UNITED STATES PATENT AND TRADEMARK OFFICE

APPLICATION NO.	FILING DATE	FIRST NAMED INVENTOR	ATTORNEY DOCKET NO.	CONFIRMATION NO.
10/732,873	12/09/2003	John W. Matthews	SF-1	6841
25917	7590	09/14/2005	EXAMINER	
LANGLOTZ PATENT WORKS, INC.			HAN, JASON	
PO BOX 759			ART UNIT	
GENOA, NV 89411			PAPER NUMBER	
			2875

Office Action Summary	Application No. 10/732,873	Applicant(s) MATTHEWS ET AL. 	
	Examiner Jason M. Han	Art Unit 2875

DETAILED ACTION

FIG. 3

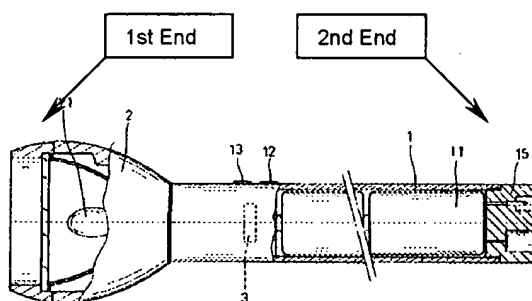
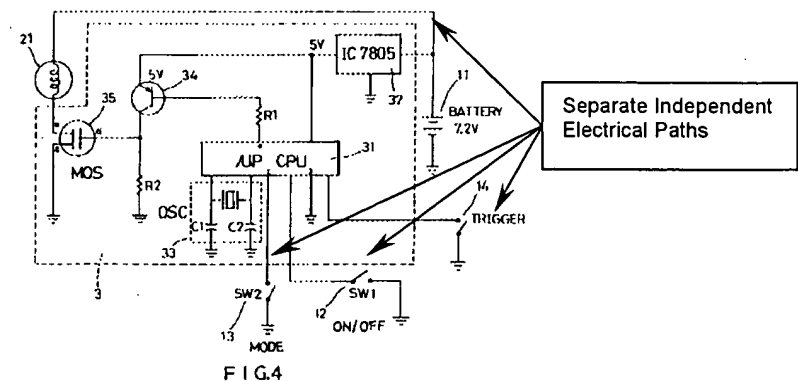
3. Claims 1-3 are rejected under 35 U.S.C. 102(b) as being anticipated by Ko et al. (U.S. Patent 6307328).
4. With regards to Claim 1, Ko discloses a flashlight including:
- A lamp [Figures 3-4: (21)];

- A power storage element [Figures 3-4: (11)];
- A switch [Figures 3-4: (14) or Figures 3-4: (12-13)];
- An electronic controller [Figures 3-4: (3)];
- The controller having a switch input connected to the switch;

- The controller being operable in response to the input to deliver power from the power storage element to the lamp [Column 2, Lines 41-46; Column 2 Line 63-Column 3, Line 1]; and
- The flashlight having an elongated housing [Figure 3: (1)] having the lamp at a first end and the switch at an opposed second end [Figure 3: (14)], and including at least two independent electrical paths between the first and second ends.

5. With regards to Claim 2, Ko discloses the switch being operably connected directly to the switch input [Figure 4 – note drawing on top of page].
6. With regards to Claim 3, Ko discloses the controller, lamp, and power storage element being connected to each other via a power circuit bypassing the switch, such that current for illuminating the lamp does not pass through the switch [Figure 4 – note the control circuit (3) permits bypassing of all three switches (12-14)].

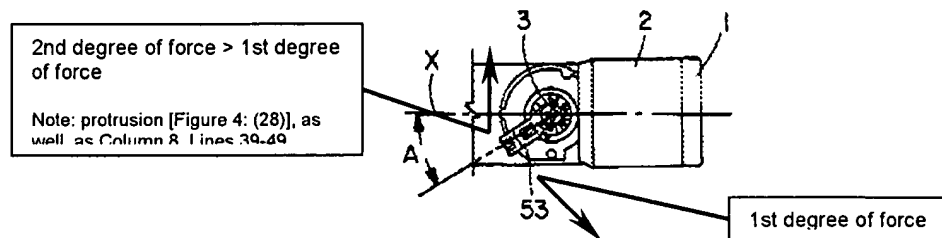
9. With regards to Claim 9, Nilssen discloses the switch including a plurality of separate contact elements [Figure 1: (D1, D2/TP1, TP2)] each connected to a respective electrical component [Figure 1: (SC, SR)], and all operable to contact a

common contact [Figure 1: (SC1, SC2)] sequentially in response to movement of a switch actuator [Figure 1: (SA)], such that the number of separate contacts contacting the common contact is based on the degree of applied external force.

10. With regards to Claim 10, Nillsen discloses the switch including a resistor network [Figure 1: (SR)] where the electrical states include a plurality of different resistance values.

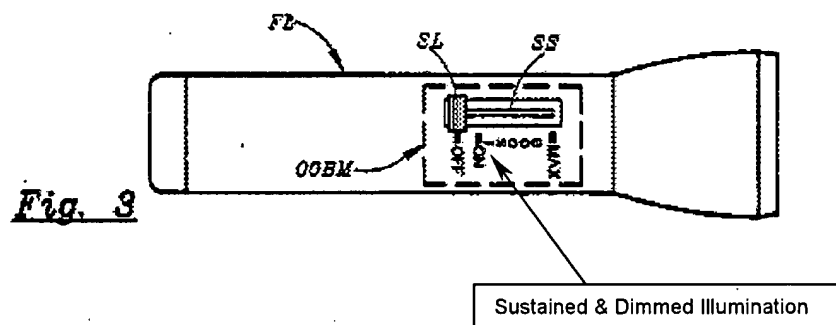
Nilssen teaches a switch [Figure 1: (SW); Figure 3] operable within a range of conditions and operable to transmit an electrical state corresponding to a condition to a controller [Figure 1: (FCM); Column 2, Lines 18-22]; the switch having a plurality of

different electrical states in addition to an off state [Figure 3], wherein the electrical state is based on a degree of externally applied force [Column 1, Lines 28-45], wherein the switch includes a plurality of separate contact elements [Figure 1: (D1, D2/TP1, TP2,)] each connected to a respective electrical component [Figure 1: (SC, SR)], all of which are operable to contact a common contact [Figure 1: (SC1, SC2)] sequentially in response to movement of a switch actuator [Figure 1: (SA)] such that the number of separate contacts contacting the common contact is based on the degree of applied external force, and wherein the switch includes at least a resistor [Figure 1: (SR)] where the electrical states include a plurality of different resistance values.

It would have been obvious to one ordinarily skilled in the art at the time of invention to modify the switch of Ko to incorporate the manual intensity switch of Nilssen in order to provide a user with greater control of the illumination brightness, whereby varying pressures or forces may be applied accordingly to a desired intensity preference. Such a tactile feature permits greater sensitivity to a user, and thus, command of the device.
